# SC8156 & SC8154 IBM Final Test Packing Label Change

PCN Update Notification # 14251A

# SC8156/54 Packing Label Change

# SC8156/54 Intermediate Box Label Change

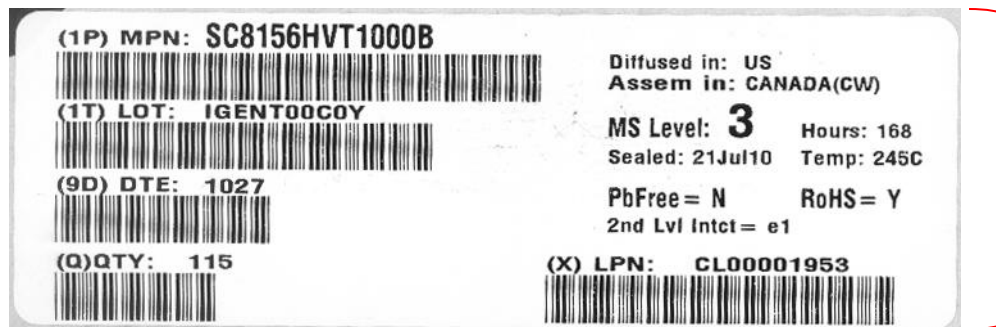
New intermediate box label for material tested at IBM Test

Additional data used for packing traceability at IBM

# SC8156/54 Moisture Barrier Bag Label Change

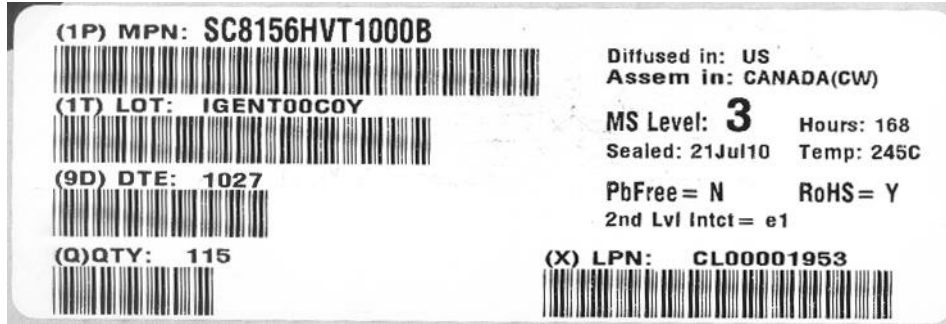
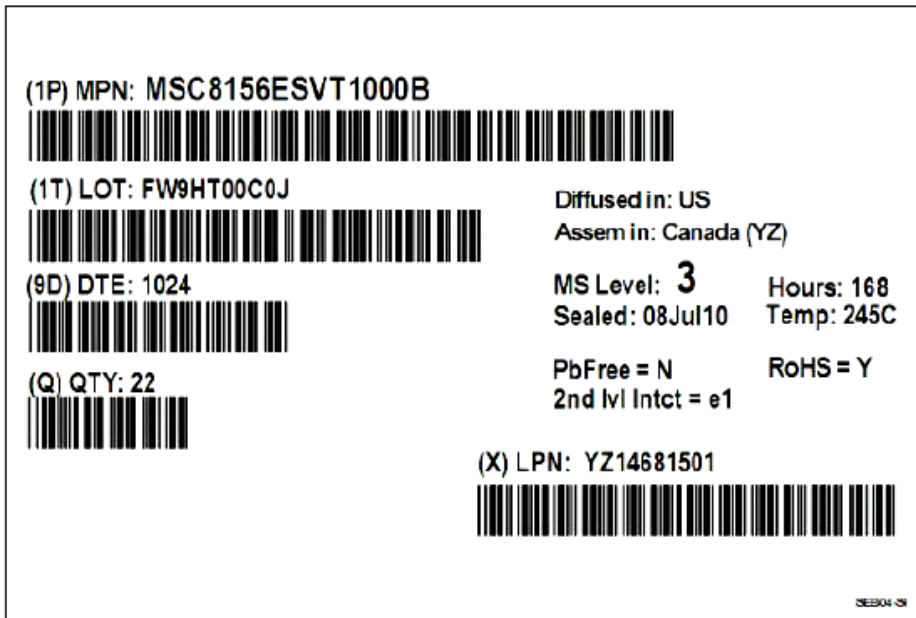
New MBB label for material tested at IBM Test
